City of Detroit
Inter-Departmental Communication

RE: Petition No. 614
Request to Vacate the East/West Alley in the Block Bound by Ellery, Waterloo,
Elmwood, and East Vernor Hwy.

**Detroit Water & Sewerage Department
Requirements and Provisions for Petition No. 614**

REQUEST TO OUTRIGHT VACATE
 THE EAST/WEST PUBLIC ALLEY, 12 FT. WD.
 IN THE BLOCK BOUND BY
 ELLERY, WATERLOO ST., ELMWOOD AVE.
 AND E. VERNOR HWY.

CITY OF DETROIT CITY ENGINEERING DEPARTMENT SURVEY BUREAU	
JOB NO.	01-01
DRWG. NO.	X 614

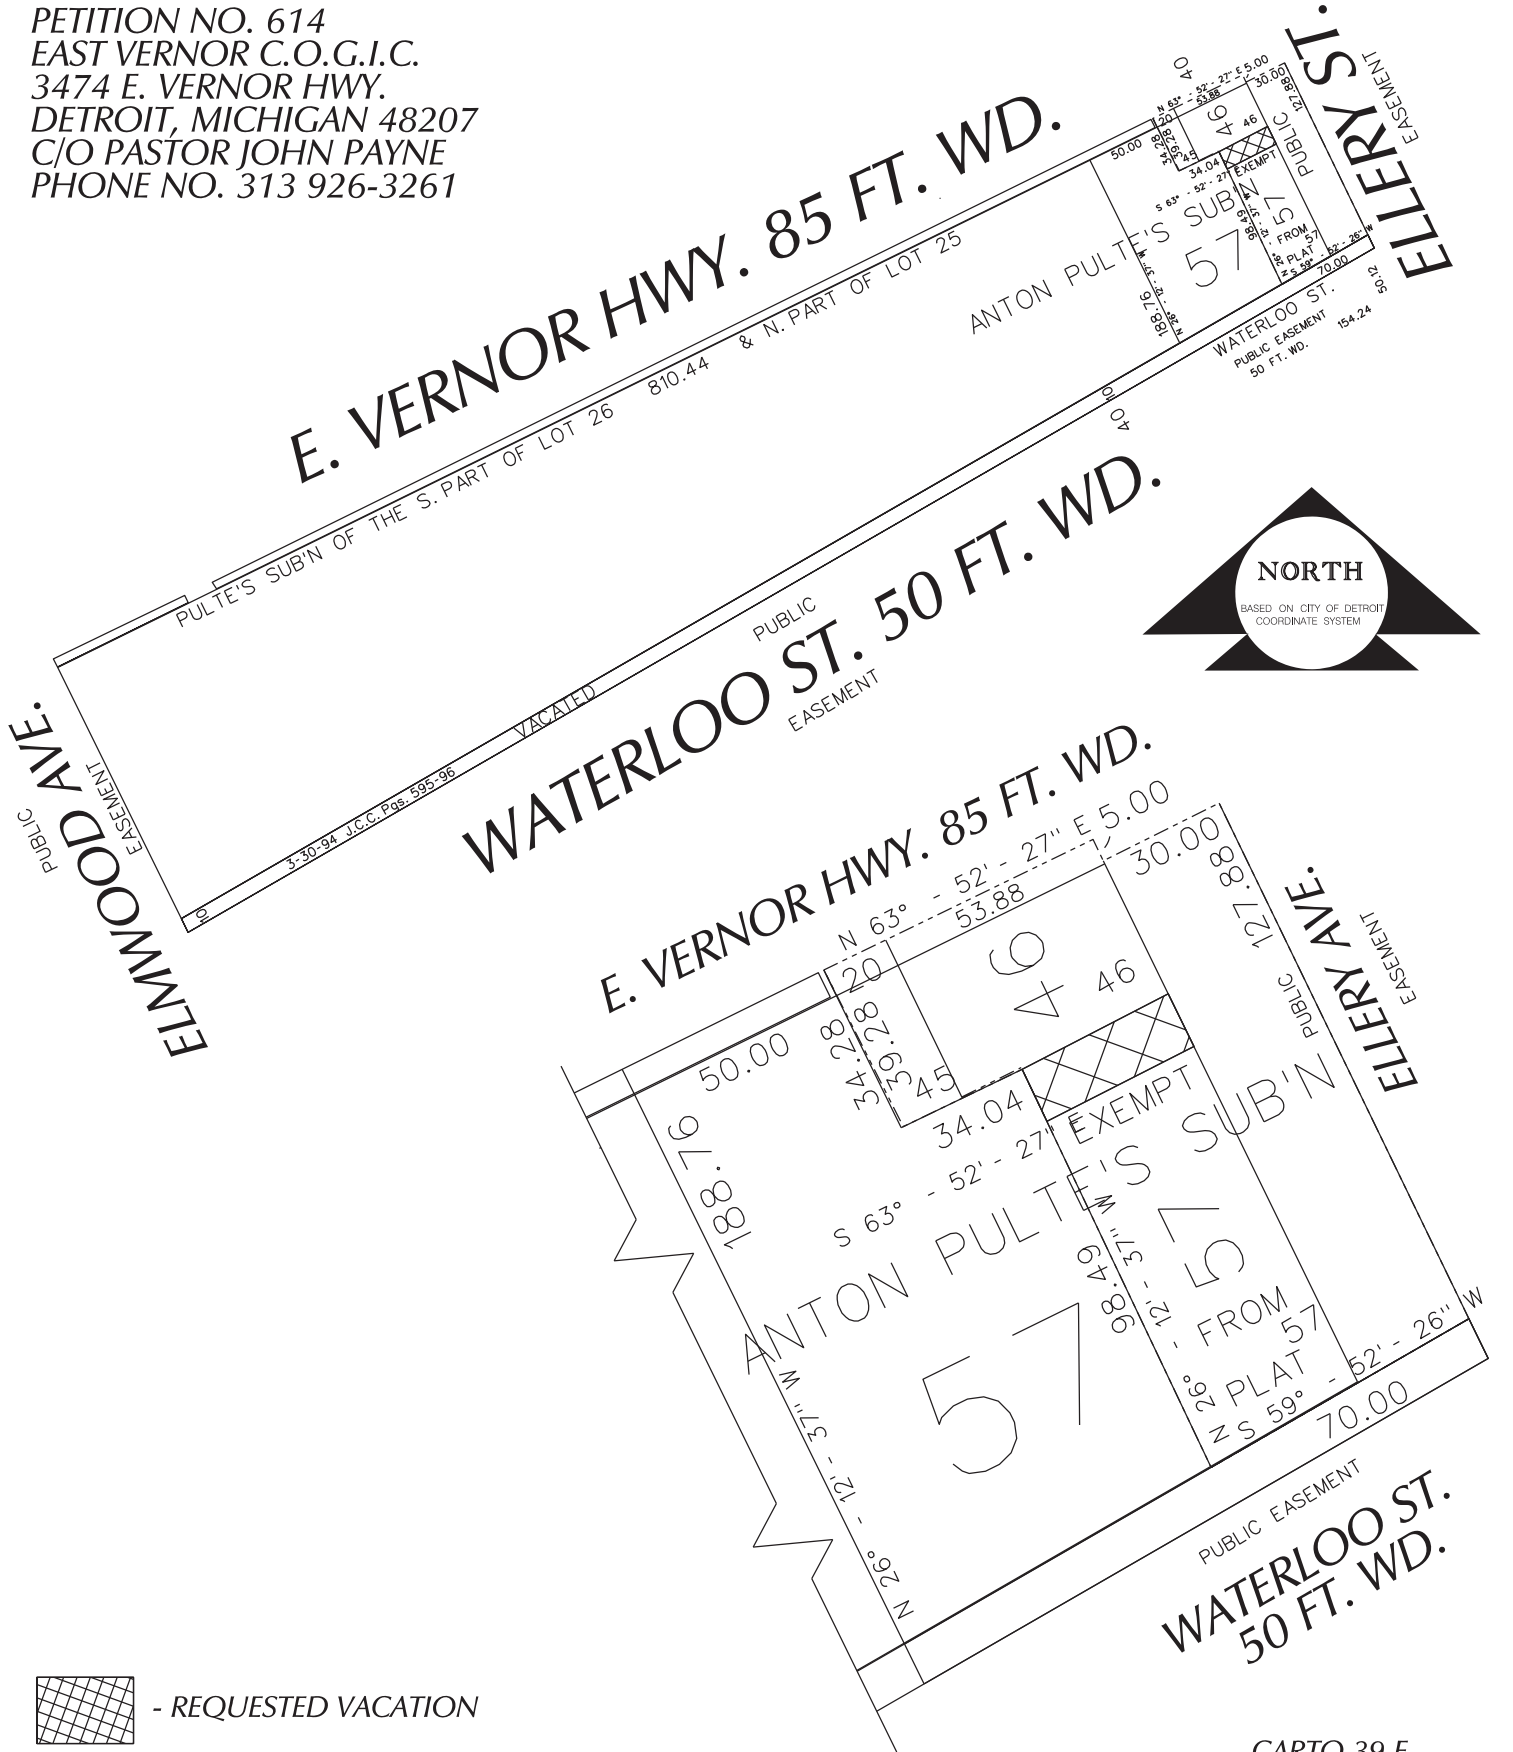
- Our records indicate that there is a sewer in the alley. DWSD objects to the requested vacation. However, DWSD has no objection if petitioner agrees to relocate the sewer in accordance with the attached Provisions for Relocation at no cost to DWSD.

Provided that the petitioner (Petition No. 614) shall design and construct proposed lateral sewer and to make the connections to the existing public sewers as required by the Detroit Water and Sewerage Department (DWSD) prior to construction of the proposed

Provided, that the petitioner shall grant to the City a satisfactory easement for the lateral sewers; and further
